Project	<b>IEEE 802.16 Broadband Wireless Access Working Group</b> < <a href="http://ieee802.org/16">http://ieee802.org/16</a> >	
Title	<b>MRS Handover</b>	
Date Submitted	<b>2007-01-08</b>	
Source(s)	<p>Yousuf Saifullah, Shashikant Maheshwari, Haihong Zheng Nokia 6000 Connection Drive, Irving, TX</p> <p>Sungkyung Kim Sungcheol Chang Chulsik Yoon ETRI 161, Gajeong-dong, Yuseong-Gu, Daejeon, 305-350, Korea</p>	<p>Voice: 972 894 5000 Fax: <a href="mailto:Yousuf.saifullah@nokia.com">Yousuf.saifullah@nokia.com</a>, <a href="mailto:shashikant.maheshwari@nokia.com">shashikant.maheshwari@nokia.com</a>, <a href="mailto:haihong.1.zheng@nokia.com">haihong.1.zheng@nokia.com</a></p> <p><a href="mailto:cyrano@etri.re.kr">cyrano@etri.re.kr</a></p>
Re:	This is a response to the call for proposals 80216j-06_034.pdf	
Abstract	This contribution proposes Mobile RS handover procedure.	
Purpose	Add proposed spec changes in P802.16j Baseline Document (IEEE 802.16j-06/026r1)

## **MRS Handover**

Figure 1: MRS Handover

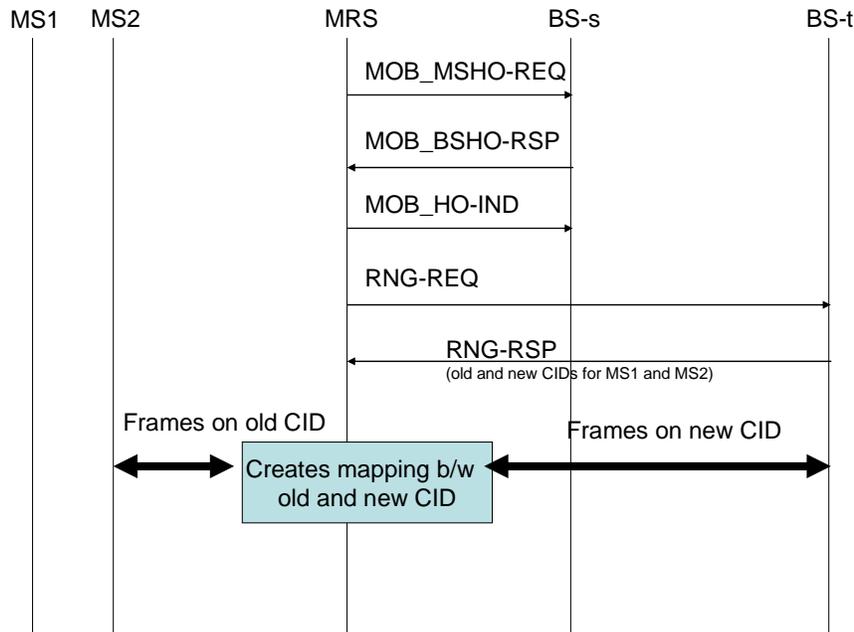
1. MRS sends MOB\_MSHO-REQ message to the serving BS on its basic CID for initiating handover.
2. The serving BS sends MOB\_BSHO-RSP message to the MRS. The serving BS may send the MAC addresses and CIDs of the MSs under MRS to the target BS over the backbone. It receives HO\_ID and sends HO\_ID in the MOB\_BSHO-RSP message.

3. The MRS sends MOB\_HO-IND message to the serving BS.
4. The MRS performs network re-entry by sending RNG-REQ containing HO\_ID. It also sends serving BS ID and an indication that RNG-REQ is from MRS. If the MRS shares a security association with the target BS, it sends HMAC/CMAC in the message. The MRS may not be able to receive HO\_ID from the serving BS, if the MOB\_BSHO-RSP message is not received by the MRS. The MRS sends the serving BS ID to the target BS. The target BS uses the serving BS ID to contact the serving BS and retrieves the MAC addresses and CIDs of the MSs using backbone procedures.

5. The BS assigns the CIDs for MS1 and MS2, and sends it to MRS in RNG-RSP. MRS creates mapping between old and new CID for each MS. It swaps them for UL/DL traffic and signaling. In this way no signaling procedure is initiated for MS1 and MS2.

During swapping of CID in the MPDU header, MRS may also need to recalculate and replace CRC, which is a minor calculation. CMAC digest is calculated using CID. The MR-BS calculates CMAC on the old CID. Figure 1 shows RS initiated handoff. A BS initiated HO for mobile RS is similar.
